FINAL PLAT OF
"DONALDSON - TALBERT ADDITION"
SEDGWICK COUNTY, KANSAS
IN THE SW 1/4 OF SECTION 12, T28S, R1W OF THE 6TH P.M.

RE: S/D 99-85 – One-Step Final Plat of DONALDSON-TALBERT ADDITION

At the regular meeting of the Subdivision Committee of the Metropolitan Area Planning Commission on Thursday, December 2, 1999, the above captioned plat was considered. The action of the Committee was to approve the final plat, subject to:

CASE NUMBER: S/D 99-85 -- DONALDSON-TALBERT ADDITION

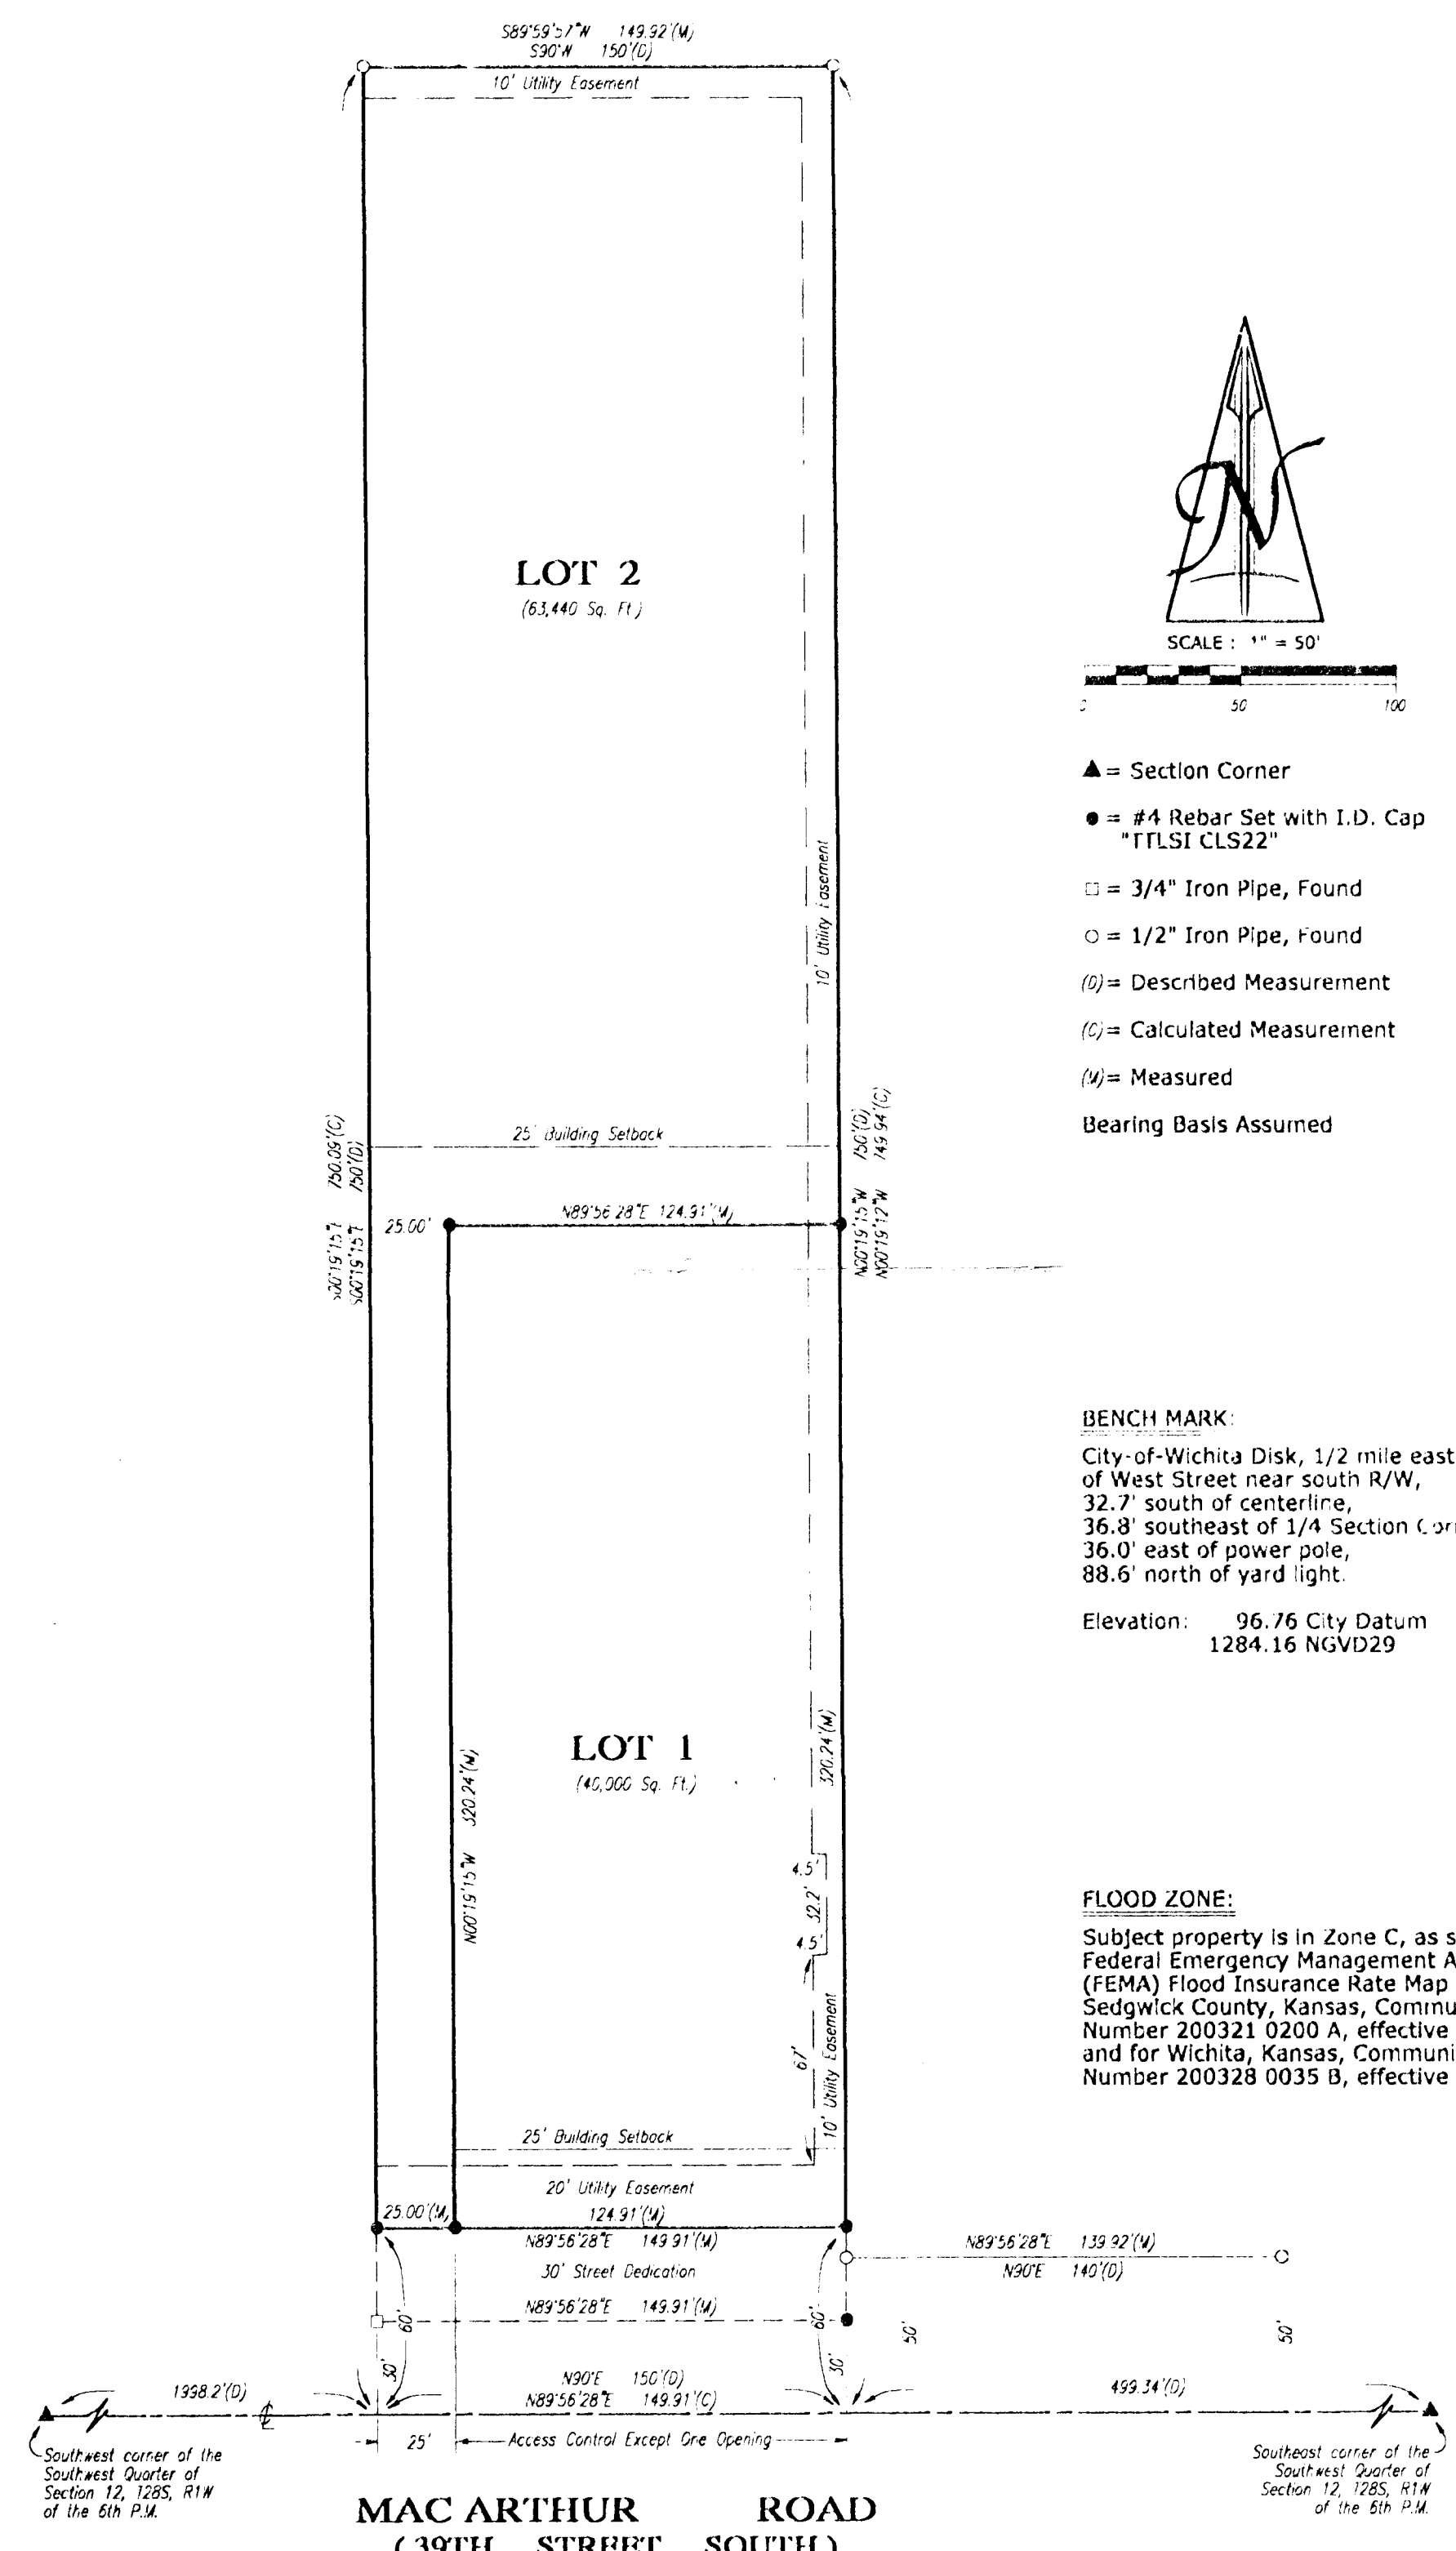
- A. Since this property is adjacent to the City of Wichita, the Applicant shall request annexation into the City. Upon annexation, the property will be zoned SF-6, Single Family Residential. If annexation is completed prior to the plat's submittal for City Council review, the County Commissioner's signature block may be eliminated.

- B. Since neither municipal water nor sanitary sewer is available to serve this property, the applicant shall contact the Environmental Health Division of the Health Department to find out what tests may be necessary and what standards are to be met for approval of on-site sewerage facilities and water wells. A memorandum shall be obtained specifying approval.

- C. City Engineering requests the Applicant attempt to obtain a valid sewer petition. A petition for future City water (and sewer if applicable), shall be required.

- D. City/County Engineering needs to comment on the status of the applicant's drainage plan. An off-site drainage easement is required.
- E. City Fire Department requires a 20-foot gravel road with a turnaround to within 150 feet of the most remote point of any structure. A site plan shall be submitted to City Fire Department prior to the issuance of a building permit.

- I. The platting text shall include language that a drainage plan has been developed for the plat and that all drainage easements, rights-of-way, or reserves shall remain at established grades or as modified with the approval of the applicable City or County Engineer, and unobstructed to allow for the conveyance of stormwater.

- K. The applicant's engineer is advised that the Register of Deeds is requiring the name(s) of the notary public, who acknowledges the signatures on this plat, to be printed beneath the notary's signature.

- O. Perimeter closure computations shall be submitted with the final plat tracing.
- P. Recording of the plat within thirty (30) days after approval by the City Council and/or County Commission.

- Q. The representatives from the utility companies should be prepared to comment on the need for any additional utility easements to be platted on this property.
